LINE	QUANTITY	UOP	CAT. NO.	ITEM NUMBER	UNIT PRICE	AMOUNT
				ADDENDUM NO. 2		
				1. TO PROVIDE RESPONSES TO VENDOR QUESTIONS.		
				2. TO PROVIDE THE PRE-BID SIGN-IN SHEETS.		
				3. TO PROVIDE UPDATED SPECIFICATIONS -		
				4-02 ACCESS ROADS		
				4. REVISED DRAWINGS ARE AVAILABLE IN COLOR PDF		
				FORMAT BY CONTACTING CANDICE STONE AT		
				THE PHILIPPI OFFICE AT 304-457-4588 EXT. 43288		
				OR 304-457-3219.		
				5. THE BID OPENING HAS MOVED FROM 05/22/2014 TO		
				05/27/2014.		
				END OF ADDENDUM NO. 2		
0001	1	JB		962-73		
				RECLAMATION: RESTORATION OF WATER		
				***** THIS IS THE END OF RFQ DEP16464 ***** TOTAL:

SOLICITATION NUMBER: DEP16464**Addendum Number: 2**

**Addendum #2 - Questions During Pre-Bid Conference
For DEP16464
Water Company and Inter-State Lumber Company
Permits S-71-79 and S-112-80**

WETER COMPANY & INTER-STATE LUMBER COMPANY
DEP 16464
PRESTON COUNTY, WEST VIRGINIA

SHT. NO.
7R
TOTAL
12

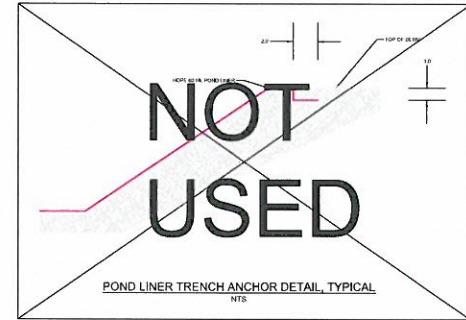
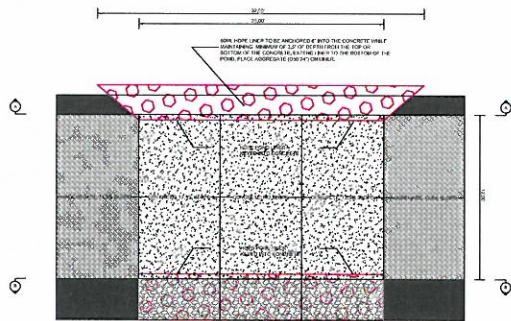
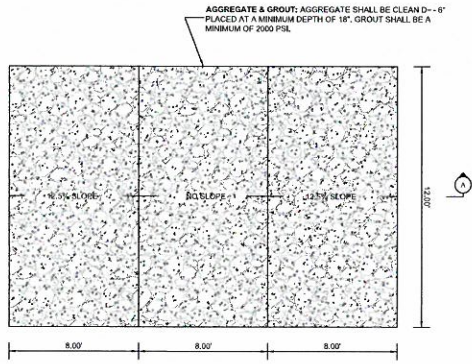
Sheet 7R of 12: POND DETAILS: The final elevations of the pond spillway and related elevations have been clarified.

REHABILITATED ROAD
SCALE: NTS

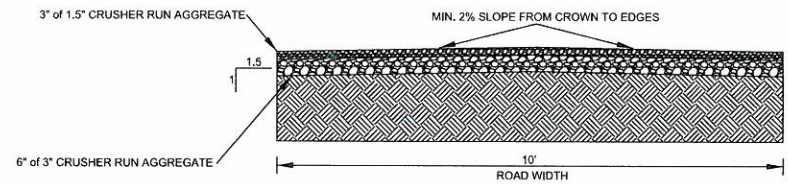
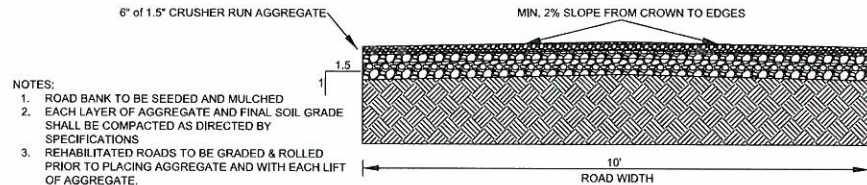
- Q1.** The project calls for the entrance road to be top dressed, but no separate detail is provided. How is the road to be top-dressed?
- A1.** Use the "Rehabilitated Road" detail as shown on Sheet 9 of 12. No separation fabric is to be used for this part of the project. In addition to roll compacting the base, the finish layer of the aggregate is to be rolled. A revised specification paragraph to clarify this requirement is included as part of this Addendum.

Sheet 9R of 12: TEXAS CROSSING, DITCH, & ROAD DETAILS. Note number four has been added to the REHABILITATED ROAD detail to clarify what Top Dressing of the road entails.

- NOTES:
- ROAD BANK TO BE SEEDED AND MULCHED
 - EACH LAYER OF AGGREGATE AND FINAL SOIL GRADE SHALL BE COMPACTED AS DIRECTED BY SPECIFICATIONS
 - REHABILITATED ROADS TO BE GRADED & ROLLED PRIOR TO PLACING AGGREGATE AND WITH EACH LIFT OF AGGREGATE.
 - ROADS TO BE TOP DRESSED SHALL USE REHABILITATED ROAD DETAIL, WITH EXCEPTION OF PLACING 3-INCH LIFT AT BEGINNING OF PROJECT AND PLACING FINAL 3-INCH LIFT AT THE CLOSE OF THE PROJECT.
